PIC18(L)F26/45/46K40 Family Silicon Errata and Data Sheet Clarification

The PIC18(L)F26/45/46K40 devices that you have received conform functionally to the current device data sheet (DS40001816F), except for the anomalies described in this document.

The following typographic corrections and clarifications are to be noted for the latest version of the device data sheet (DS40001816F):

Figure 1. 28-pin SPDIP, SSOP, SOIC

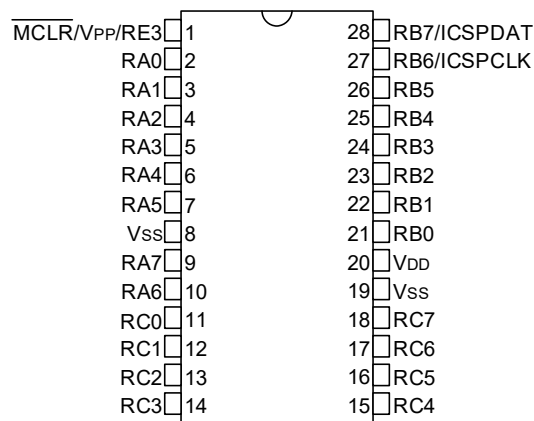
The correct marking for pin 26 on the 28-pin SPDIP/SSOP/SOIC package is **RB5**.

Figure 3. 40-pin PDIP

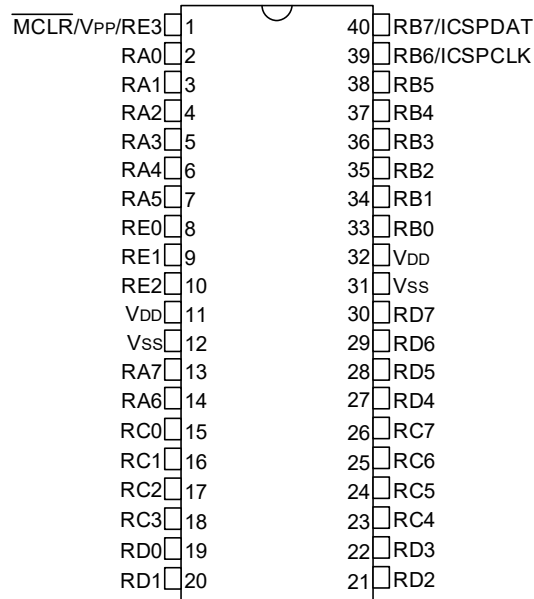
The correct marking for pin 38 on the 40-pin SPDIP package is **RB5**.

Figure 38-10: ADC Conversion Timing (ADC Clock F_{OSC} -Based)

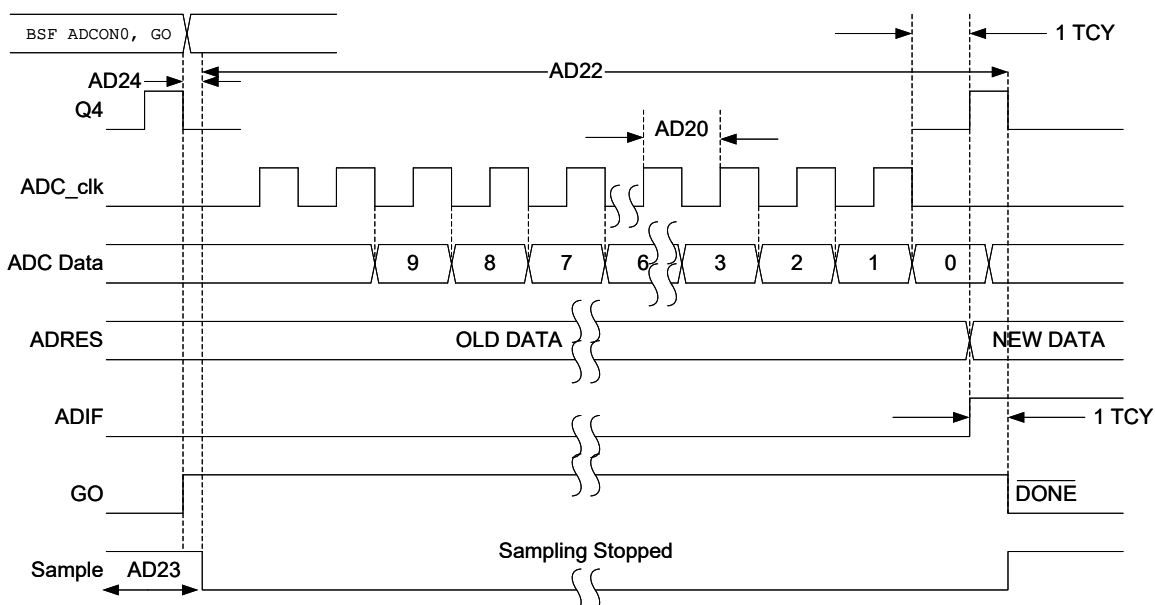
Refer to the images below for corrections of Figure 38-10 and Figure 38-11. Previously, the parameter numbers were incorrect.
